SITE DEVELOPMENT FILE DA.00.014 (REVISED)
CATHOLIC CEMETERIES-ARCHDIOCESE OF TORONTO

THAT Site Development File DA.00.014 (Revised) (Catholic Cemeteries-Archdiocese of Toronto) BE APPROVED, subject to the following conditions:

The Owner has submitted an application to amend the existing Site Plan agreement to permit a 5,370m² expansion to an existing 11,860m² mausoleum in the westerly portion of the 46.1 ha Queen Heaven cemetery, resulting in a total mausoleum building size of 17,230m², as shown on Attachment #2.

Site Plan

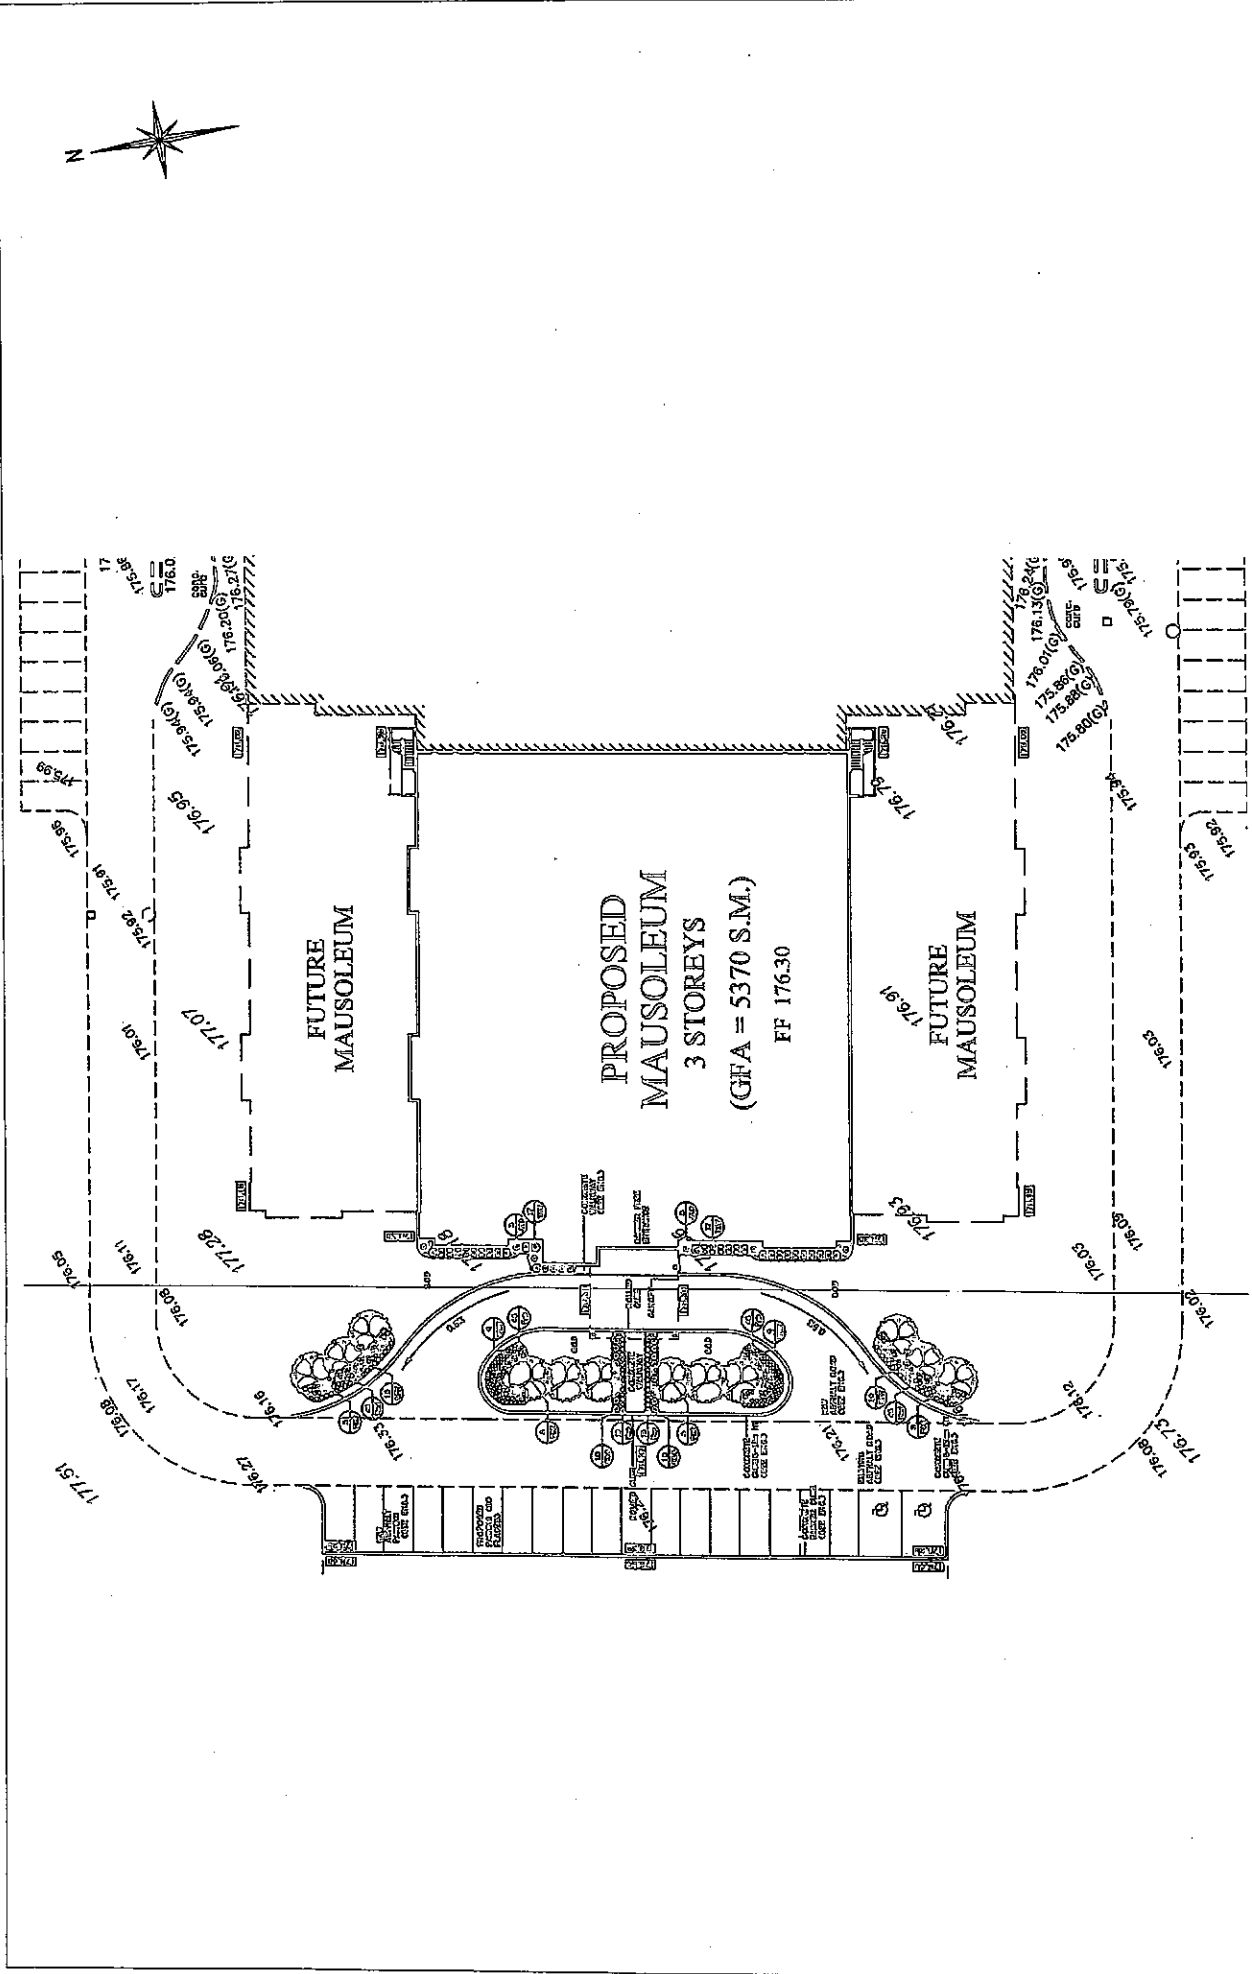
The existing mausoleum has a gross floor area of 11,860m² and is located approximately in the centre of the 46.1 ha cemetery, as shown on Attachments #1 and #2. The 5370m² mausoleum expansion is proposed to be added to the west side of the building, resulting in a total mausoleum building size of 17,230m². Also, additional driveway aisles and parking spaces will be provided to the north, south and west of the building.

The site is currently accessed by one full movement driveway from Regional Road #27. This road extends approximately 500m into the property, splitting into several winding private roadways which serve the cemetery and mausoleum. The private roadway is proposed to wrap around the perimeter of the enlarged mausoleum.

Staff will also work with the applicant to ensure that the final site plan clearly provides the dimensions of the driveway aisle for the one-way and two-way aisles.

- The site plan must clearly indicate the 407 property line.
- The site plan and attached documents do not match in terms of building size, please specify.
- Submit 2 copies of a SWMR and site servicing/grading plans
- Submit 2 copies of a Traffic Impact Study. Study must take into consideration all adjacent developments and identify all impacts to the Highway 407 interchange.
- All access to the subject site shall be via Toronto R.V. Road, located north of Highway 407

Landscape Plan

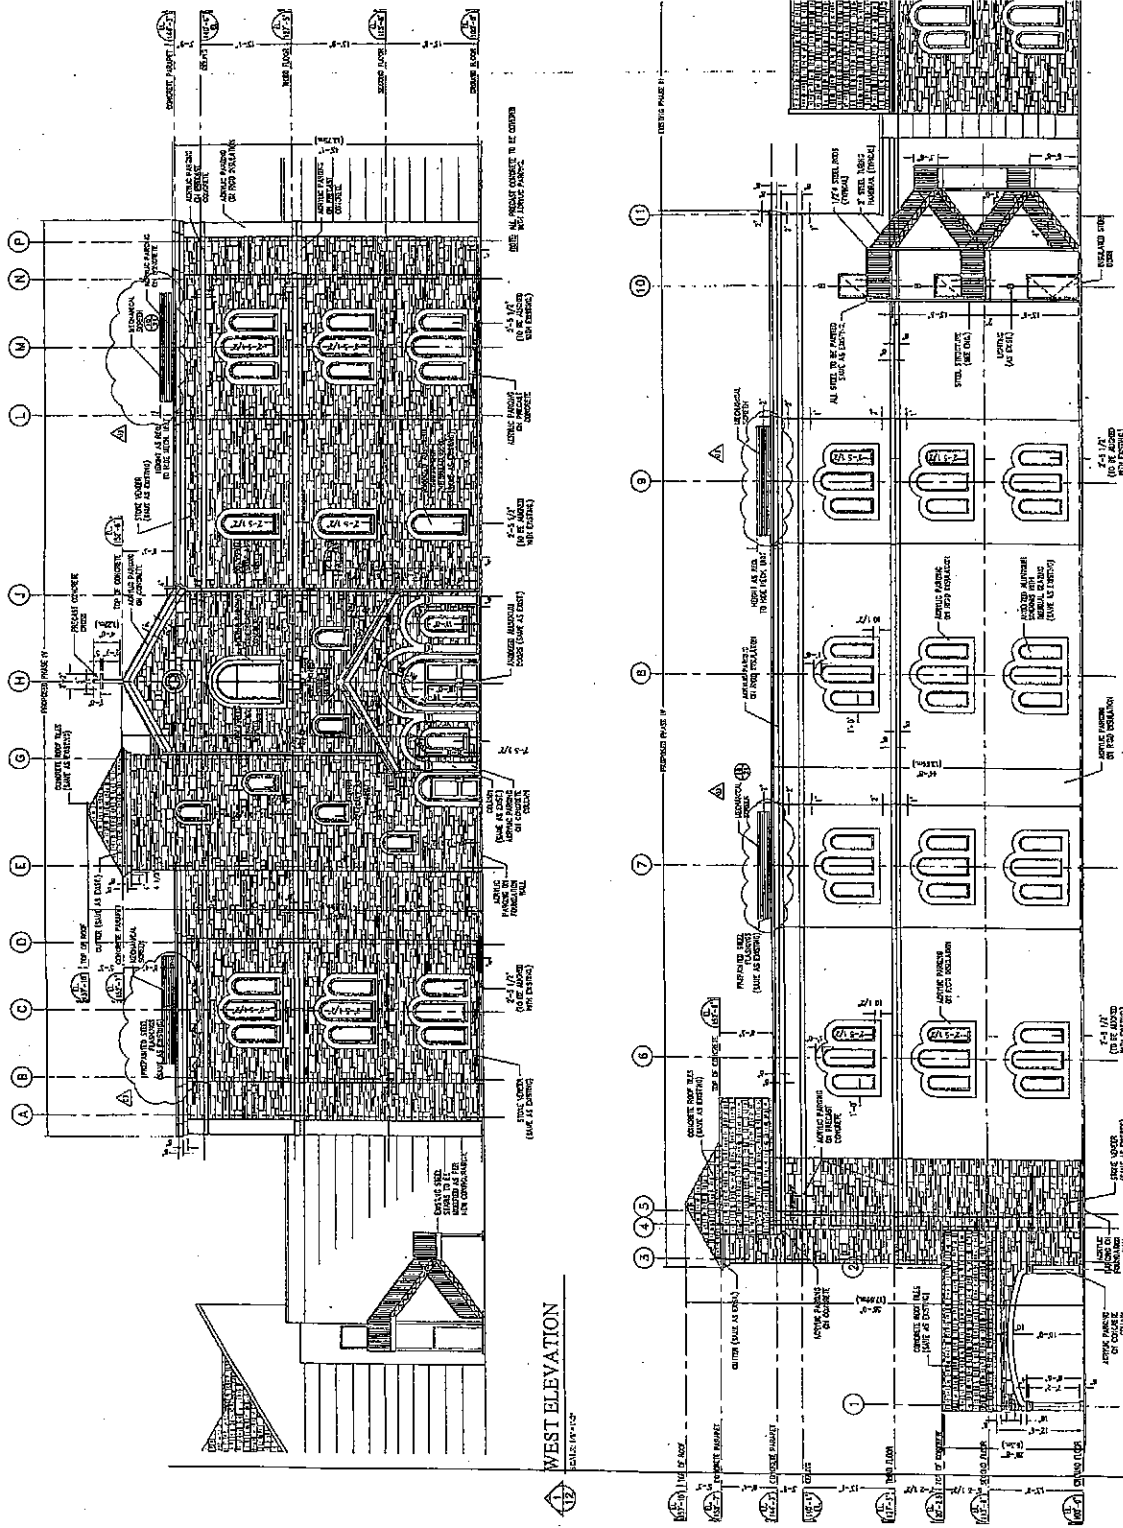
The land use plan shown on Attachment #3 proposes a variety of deciduous trees and coniferous and deciduous shrubs along the front of the westerly entrance to the proposed mausoleum addition. The proposed landscape plan is satisfactory. However, the final landscape plan must be approved to the satisfaction of the Development Planning Department.

West & South Elevations

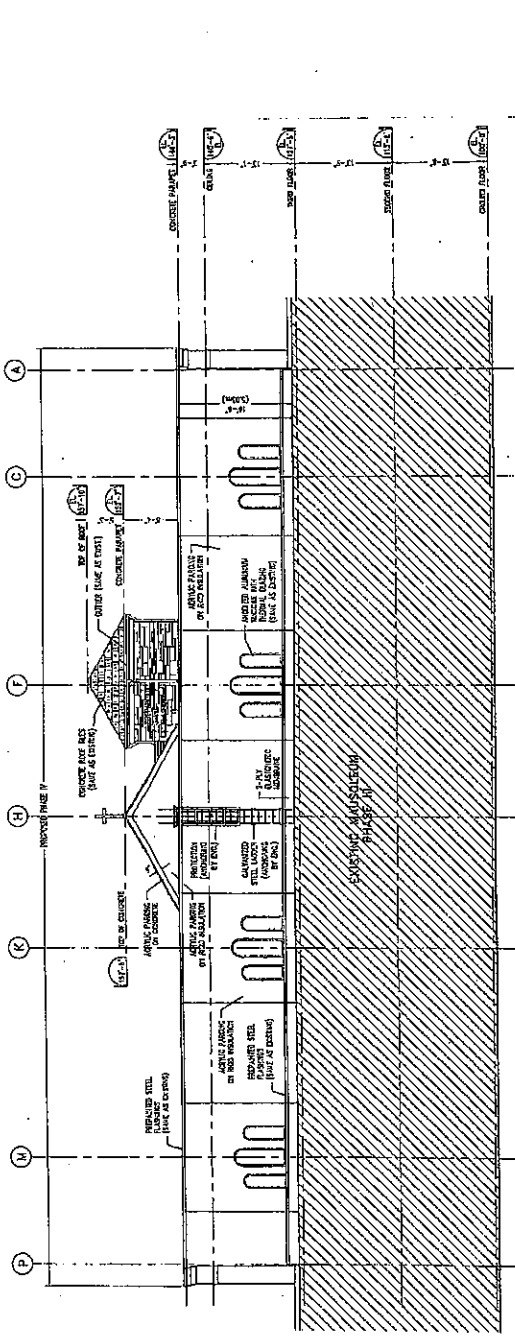
The proposed expansion will be three storeys high and have a height of approximately 17.7m to top of tower roof, the maximum height permitted by By-law 1-88 is 11m, however, Staff can support the proposed height variance as identified earlier in the report. Building materials and colours will match those of the existing mausoleum (white stone veneer and white acrylic stucco), including concrete red tile roof, with articulated white stone veneer. The westerly entrance has a covered entry feature with concrete red roof tiles and concrete columns with acrylic parging. The westerly façade will be constructed with a white stone veneer same as existing, incorporating arched windows surrounded by acrylic parging on rigid insulation or precast concrete with acrylic parging.
